ADDENDUM NO. 1

**PROJECT NO. 2159FR0315 TURKEY MOUNTAIN EAST
PARKING LOT AND TURKEY MOUNTAIN WEST PARKING
LOT**

**ADDENDUM NO. 1
TO
PROJECT NO. 2159FR0315
TURKEY MOUNTAIN EAST PARKING LOT AND
TURKEY MOUNTAIN WEST PARKING LOT**

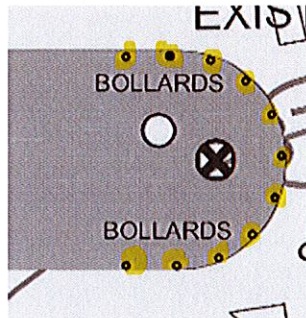
6. The plans show a bollard detail on sheet 22/C-016. It appears that the only location these are called out is on sheet 11/C-005. Are these two the only ones to be installed on the project?

- All the highlighted circles are bollards – 11 total bollards.
- The proposal has been revised to include the pay item for the 11 needed bollards.
